IN THE DRAWINGS:

Fig.8

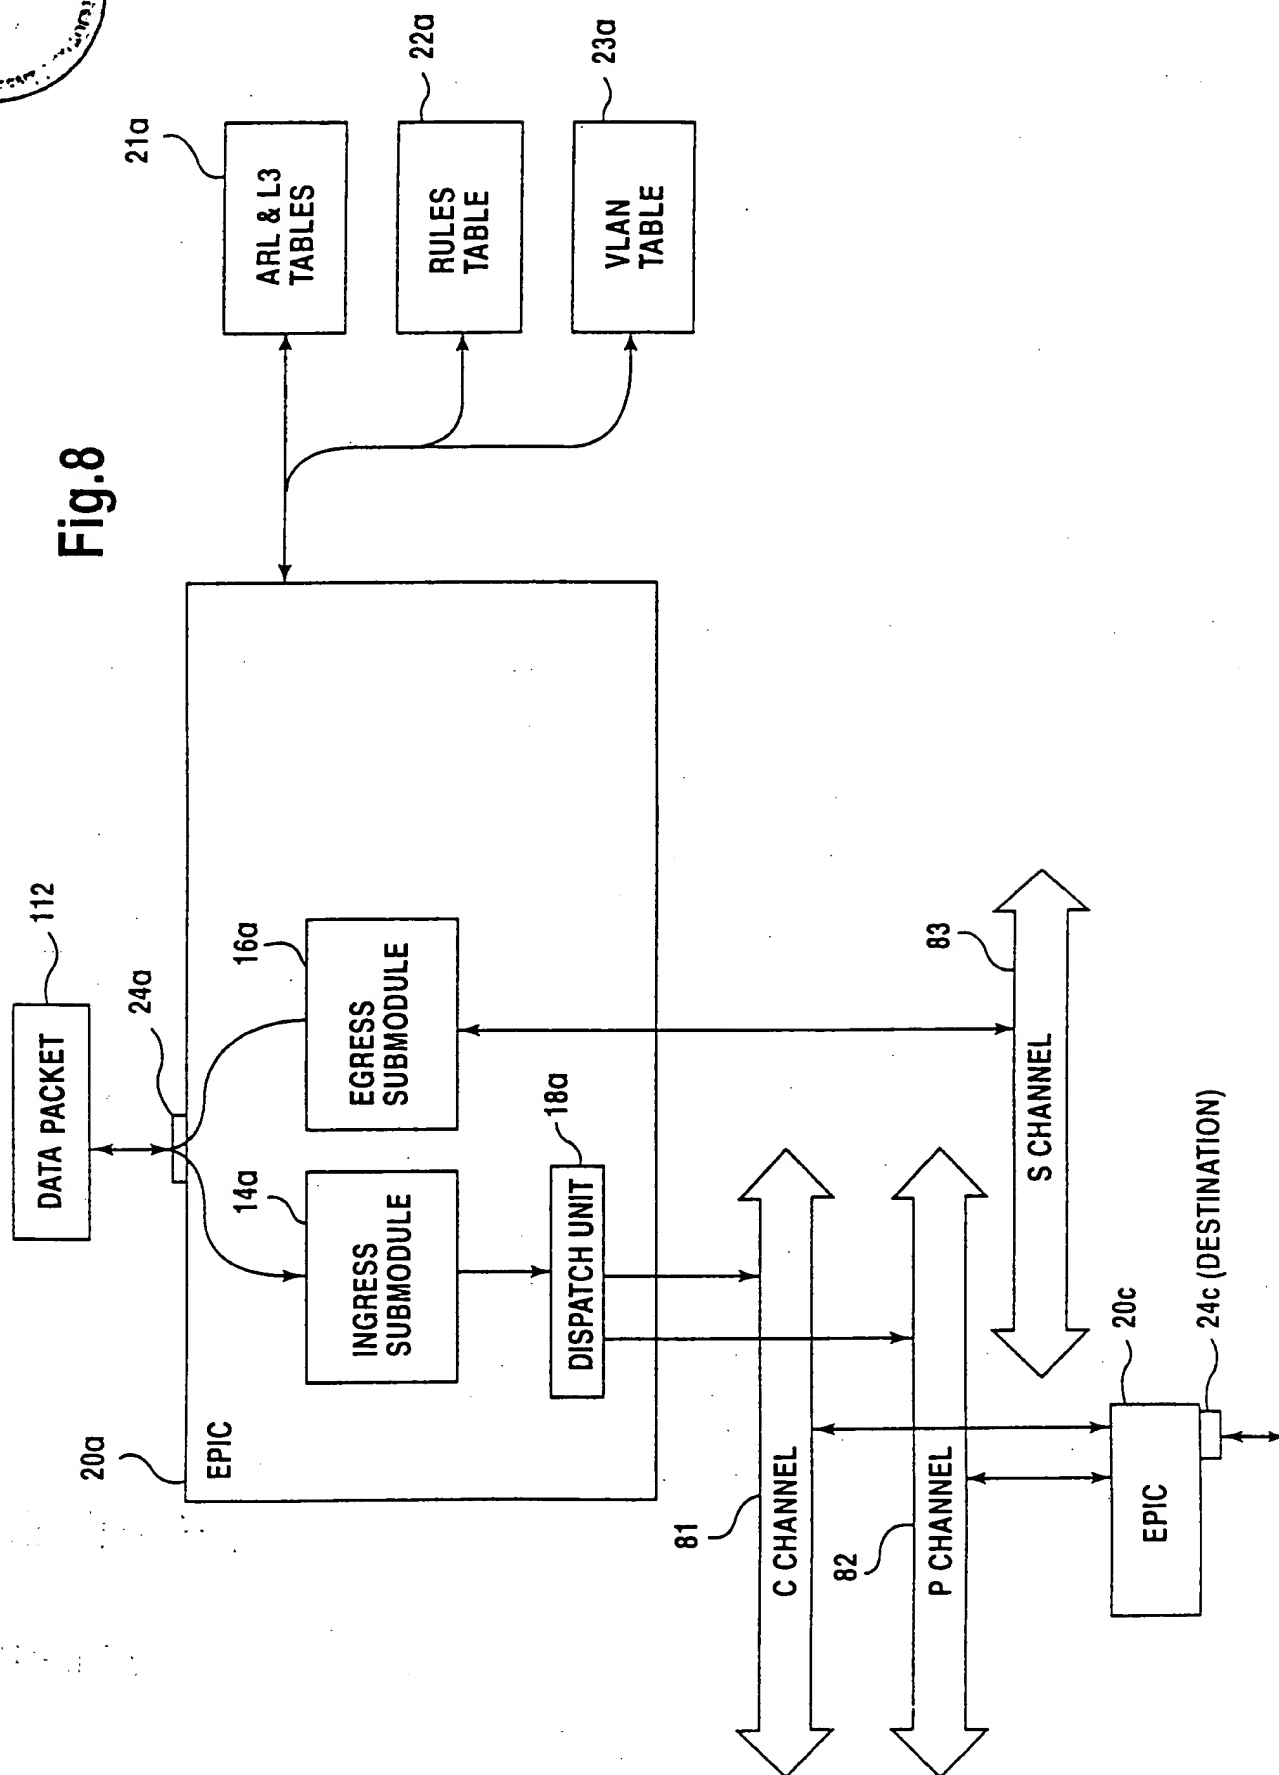
Please replace the original sheet containing Fig. 8 with the attached replacement sheet containing Fig. 8. The label for element 112 has been corrected to read "DATA PACKET" instead of "DATA POCKET".

Fig.25

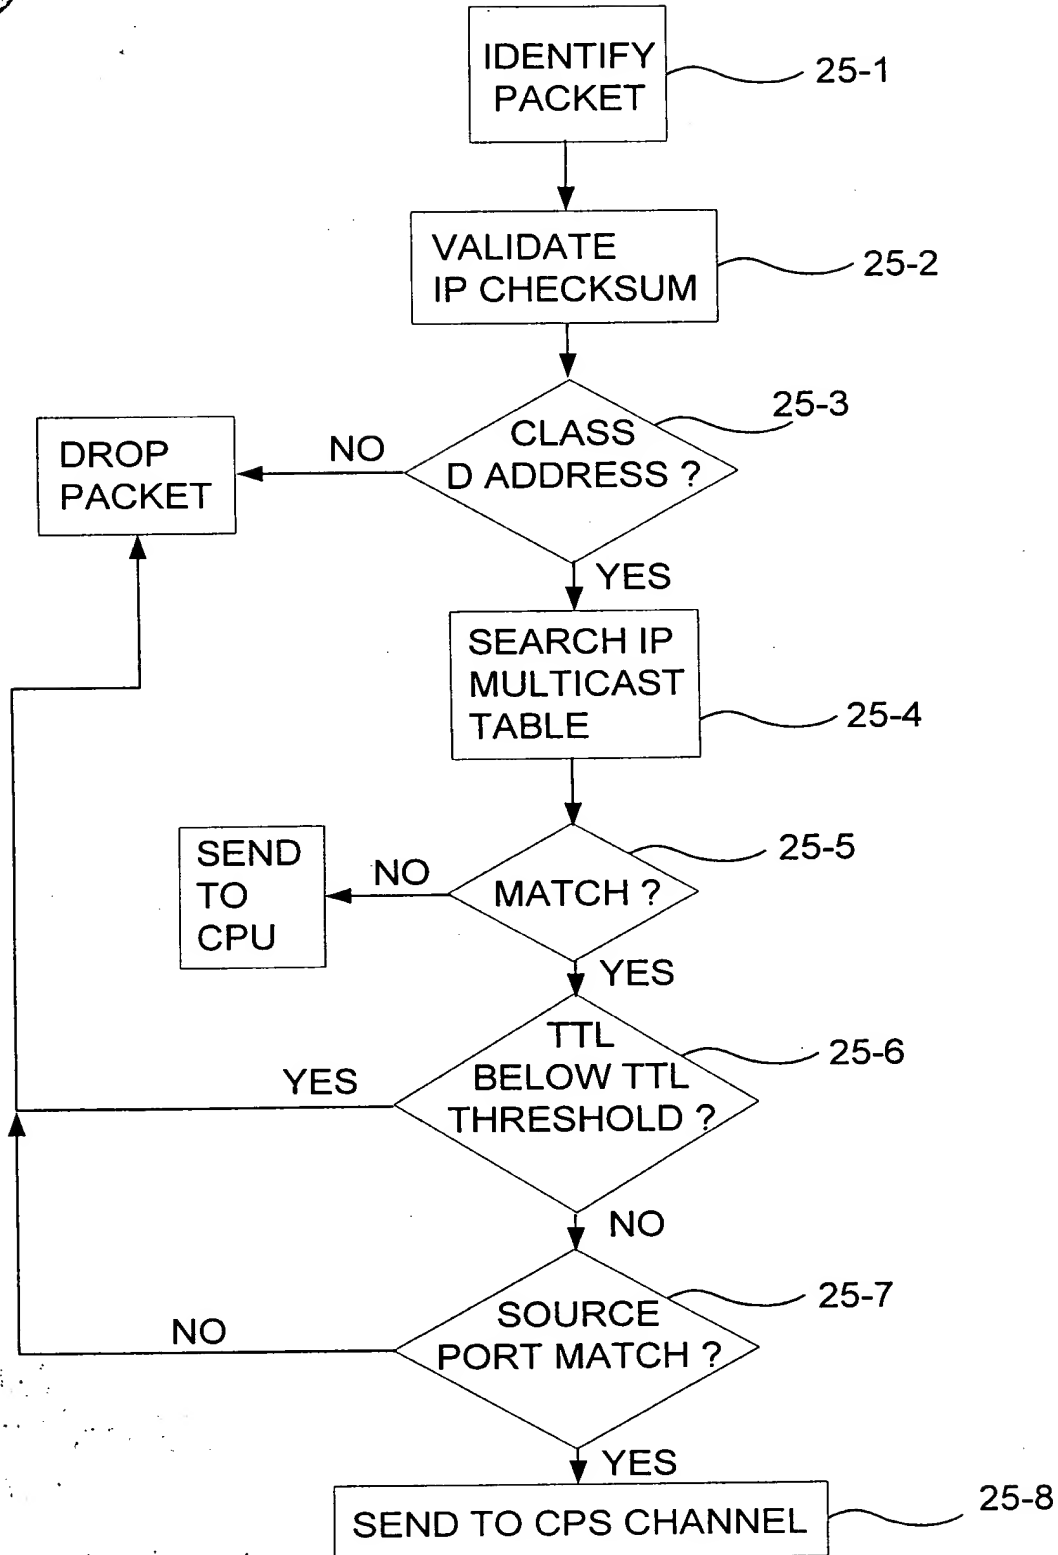
Please replace the original sheet containing Fig. 25 with the attached replacement sheet containing Fig. 25. Numerical references "25-6", "25-7" & "25-8" have been added to the lower elements in Fig. 25 to comply with their recitation in the specification.

Fig.28

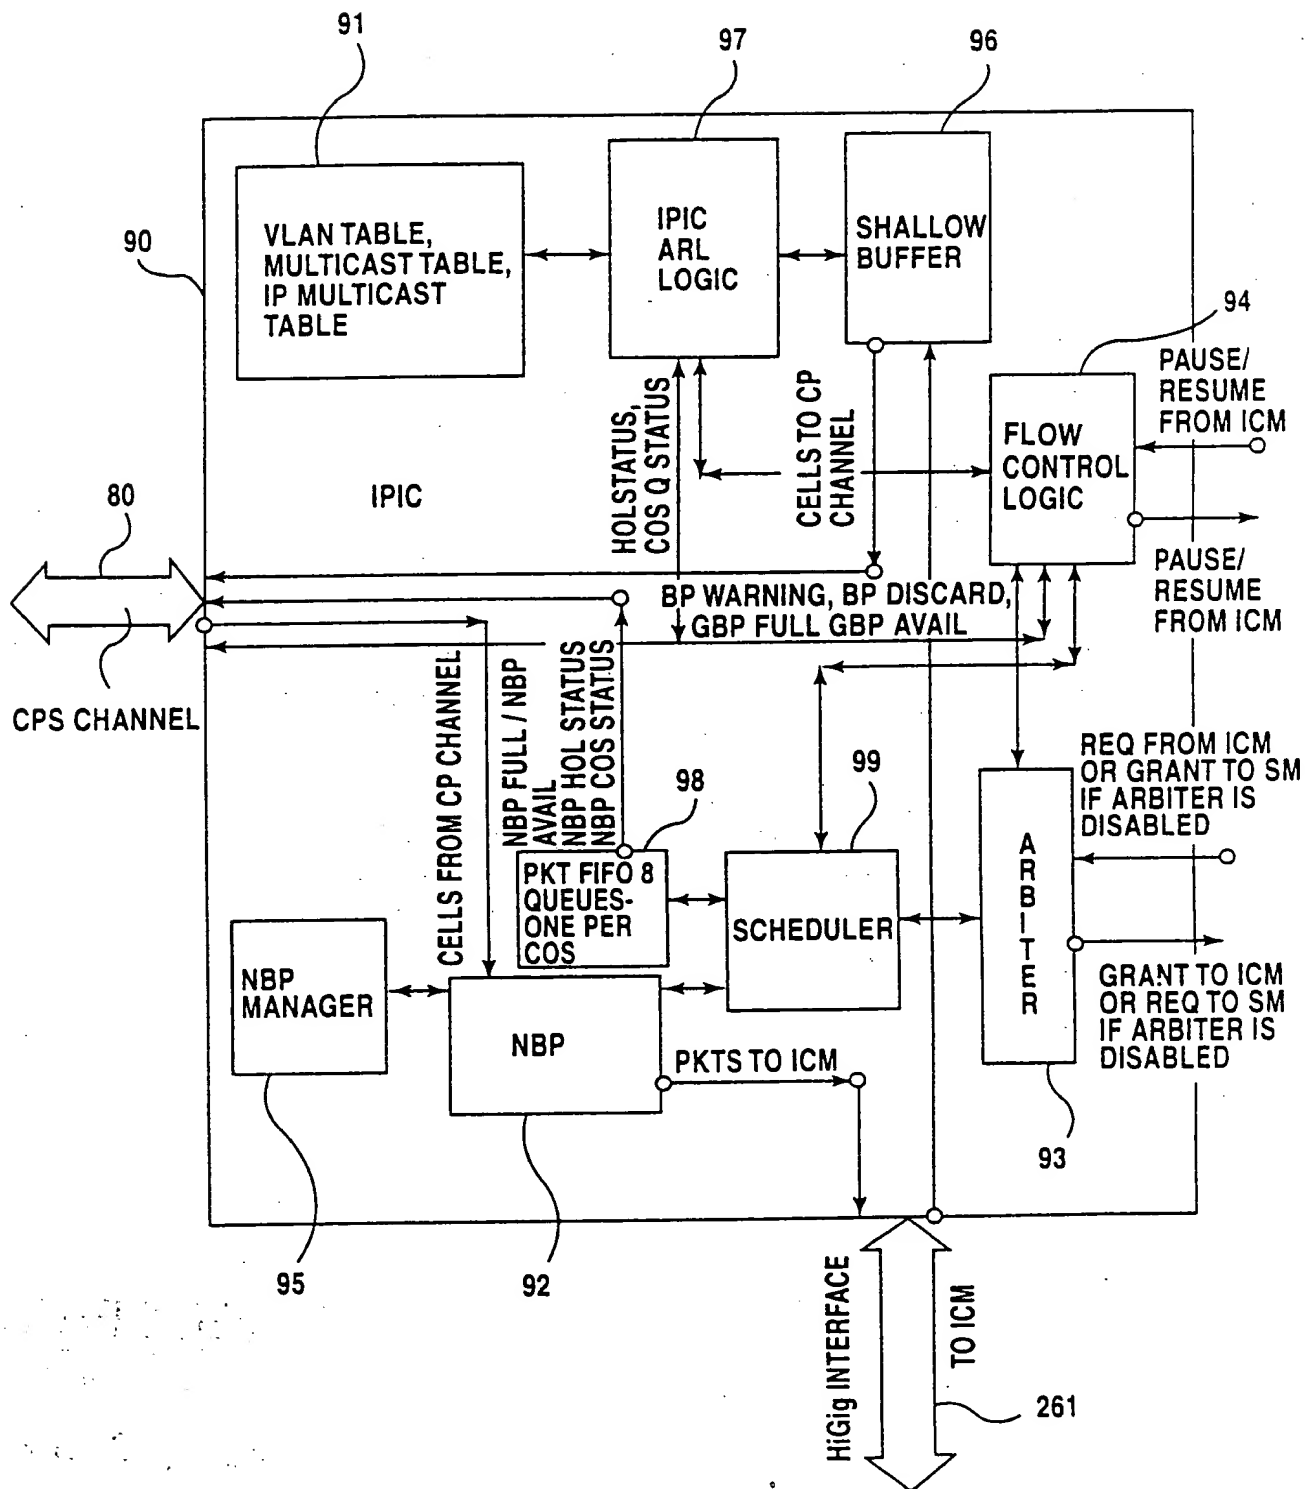
Please replace the original sheet containing Fig. 28 with the attached replacement sheet containing Fig. 28. The label for element 94 has been corrected to read "FLOW CONTROL LOGIC" instead of "FOW CONTROL LOGIC".

Fig.36

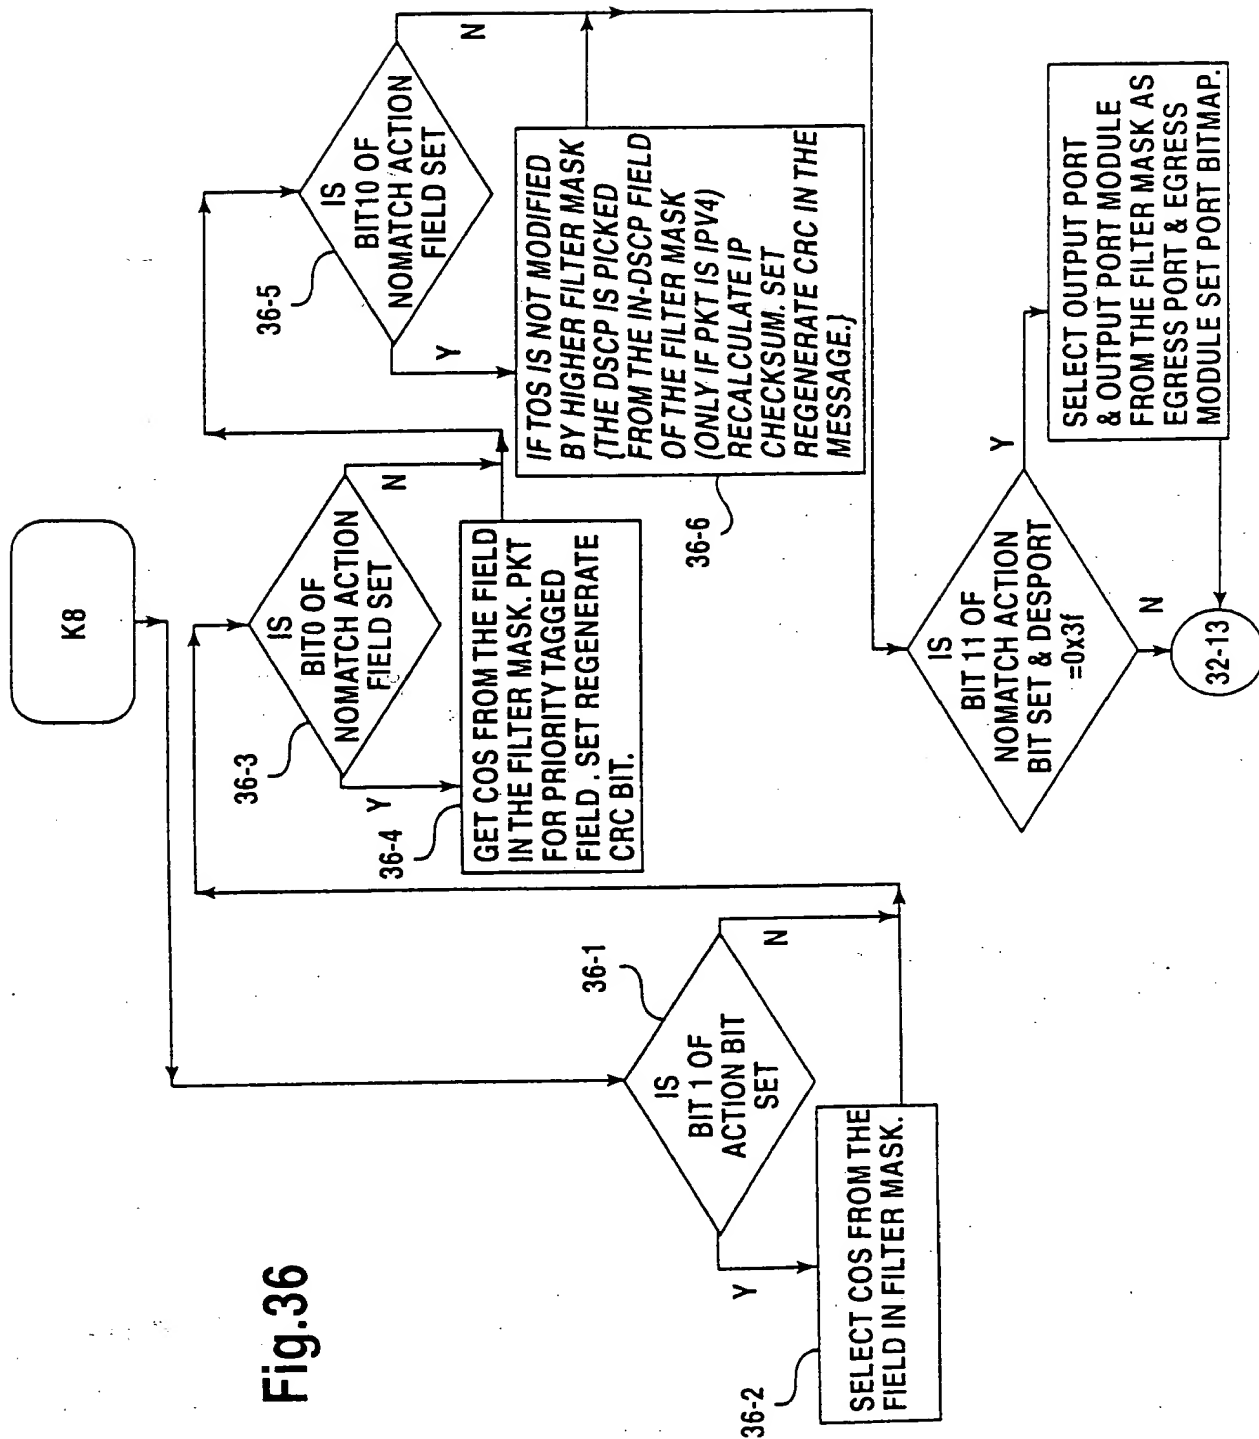
Please replace the original sheet containing Fig. 36 with the attached replacement sheet containing Fig. 36. The word "FILED", in elements 36-3 & 36-5, has been corrected to read "FIELD" in both elements.
